# SAFETY RECALL CAMPAIGN

### FRONT WIRING HARNESS INSPECTION/REPLACEMENT AND GROMMET INSTALLATION (SC170)

This bulletin provides the procedure to inspect the Front Wiring Harness for damage to the wiring insulation on some 2018MY Kia Stinger vehicles produced from July 20, 2017 through June 8, 2018.

TSB: SC170 (Rev 1) Stinger (CK) December 2018

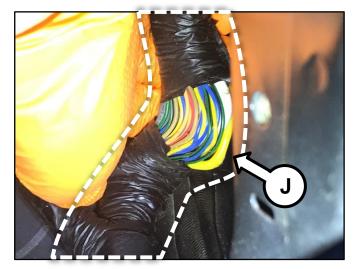
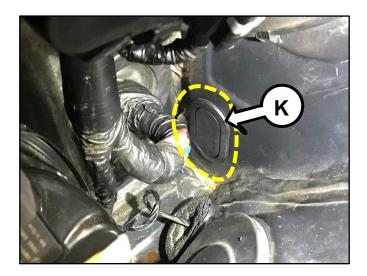
- Reach behind the hood and into the well area to slightly pull up the harness. Thoroughly inspect the harness for any damage.
  - If there is damage to the harness, open a Techline case <u>online</u> and <u>do</u> <u>not proceed</u> with claim submission until wire harness replacement approval or denial is determined. See page 6 for the Front Wiring Harness Replacement procedure.
  - If there is no damage to the harness, proceed to the next step.
- Install a rubber grommet at the opening (K) shown.
